Family Recreational Area at Northview Heights, AMP-09

IFB#600-11-26 REBID

ADDENDUM

UPDATED CONSTRUCTION DRAWINGS SET

EROSION & SEDIMENT CONTROL PLAN

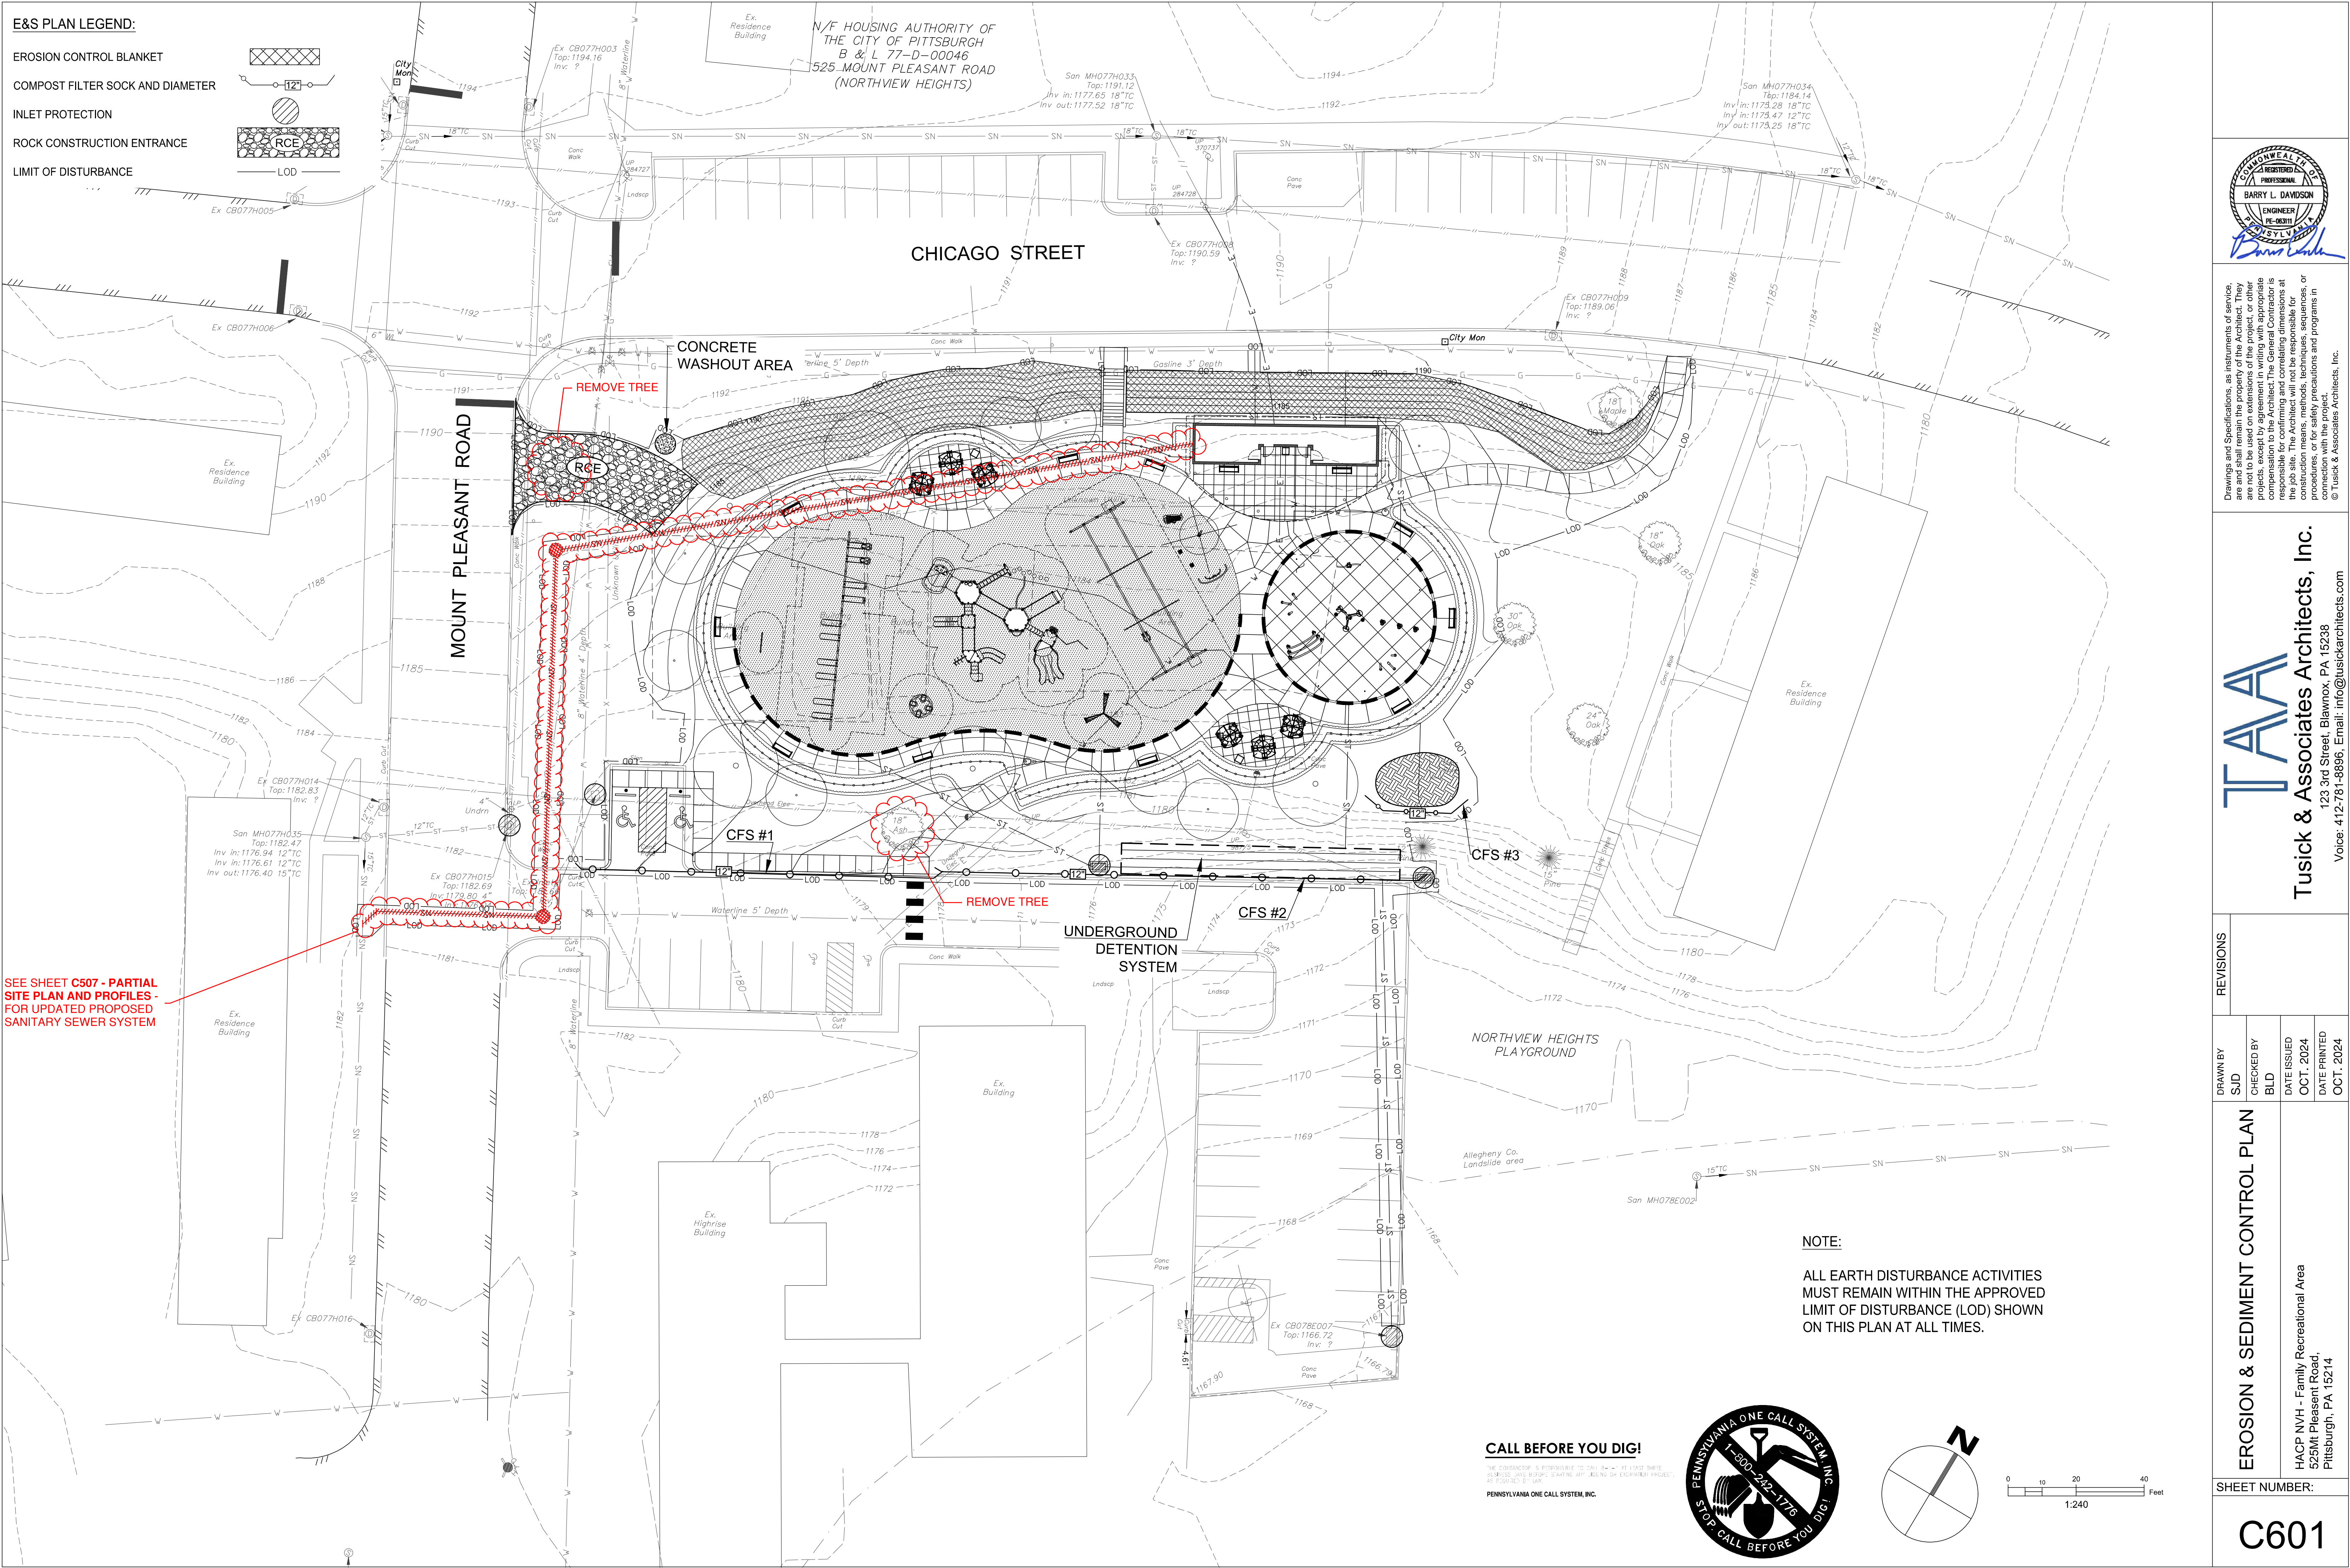
SEE SHEET C507 - PARTIAL SITE PLAN AND PROFILES - FOR UPDATED PROPOSED SANITARY SEWER SYSTEM
